**Policy Comments of the Natural Resources Defense Council (NRDC) on
the Draft Staff Report “Incremental Impacts of Energy Policy
Initiatives Relative to the 2009 Integrated Energy Policy Report
Adopted Demand Forecast”**

Docket Number 09-IEP-1C
February 25, 2010

Comments of the Natural Resources Defense Council (NRDC) on the Draft Staff Report “*Incremental Impacts of Energy Policy Initiatives Relative to the 2009 Integrated Energy Policy Report Adopted Demand Forecast*”

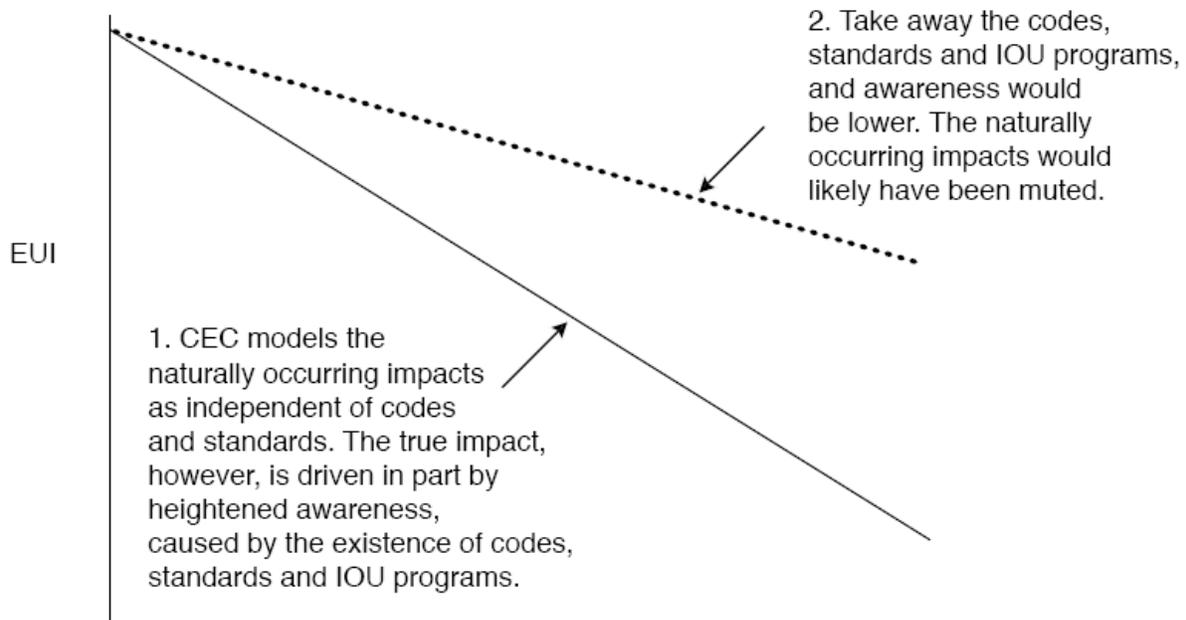
While we agree it is important to assess how the impacts of existing utility efficiency programs, uncommitted energy efficiency programs, codes and standards, and naturally occurring savings affect the load forecast, it should also be noted that these impacts do not operate independently of one other. Noting that it is difficult to quantify the interactive effect of these impacts, we recommend that the final Staff Report at a minimum identify this important concept as having an effect on the resulting demand forecast.

Specifically, we note that without the advent of utility efficiency programs it is unlikely that codes and standards would be as stringent as they are today since the markets would not be ready to provide higher levels of efficiency nor would there be sufficient technical basis to adopt many of the standards. As a result of these factors, the political process would be less likely to support higher levels of efficiency in codes and standards, which would result in a reduction of related savings. Furthermore, the identified “naturally occurring” savings in the draft Staff Report would also likely be lower due to lower consumer awareness, less information about efficient options, and the reduced availability of energy efficiency options from suppliers. Therefore, the total energy efficiency gains delivered are not only the result of these various independent influences, but also the *interaction* between utility efficiency programs and code improvements.

In addition, attempting to isolate the impact of codes and standards or existing utility efficiency programs on the utility load forecast is to adopt the traditional *ceteris paribus* notion (i.e., holding the impact of all other factors constant). That is to say, for example, that the analysis attempts to answer the question as to what the impact of codes and standards will be on the load forecast, *holding all other factors constant*. While it is necessary to distinguish between these factors for a variety of purposes, it is equally as important to account for how these interacting factors affect the overall level of energy savings. For example, utility programs alone might reduce load growth by 1.0 percent per year, codes alone by 0.5 percent per year, and private market actions alone by 0.3

percent. However, the likely effect on the load forecast is not merely the sum of these impacts (1.8 percent). The true joint effect might be 3.0 percent, for example, because the utility programs lay the foundation for political support for more-efficient code provisions, and both actions raise the efficiency awareness of consumers and producers in the market place.

The current modeling approach noted in the 2005 companion report to the 2006-2016 demand forecast³ similarly identifies savings from utility programs and codes and standards as being simply additive. However, we illustrate below that without the code changes that interact with utility programs, the resulting naturally occurring savings would be noticeably smaller than that suggested by the CEC's additive approach. This is shown by the dotted line in the figure below.

While understanding that time and resources are limited, NRDC strongly urges the final Staff Report to include, at a minimum in the caveats section in Chapter Six, a discussion of how the interactive effects of programs (including spillover) and codes and standards impact the amount of naturally occurring savings indentified in the Staff Report.
